Technical Bulletin

Bulletin Number: 324 Revision Number: R-02

SUBJECT: POLARIZATION OF WIRING HARNESS (POWER HARNESS & CABINET HARNESS)

MODELS AFFECTED: All DNCB Venders

Figure 1

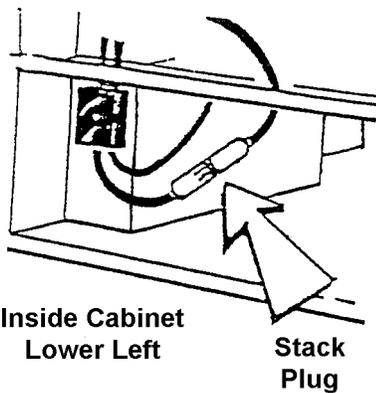
REASON: To provide serial breaks for start up of polarized harnessing. The line or hot line is #2 wire which is the smaller terminal / socket in the harness.

When a non-polarized power harness is replaced with a polarized power harness, order 804,901,95x.x1 adapter lead standard female on one end and polarized male on the other end. When a non-polarized cabinet harness is replaced with a polarized cabinet harness, order 804,901,96x.x1 adapter lead standard male on one end and polarized female on the other end.
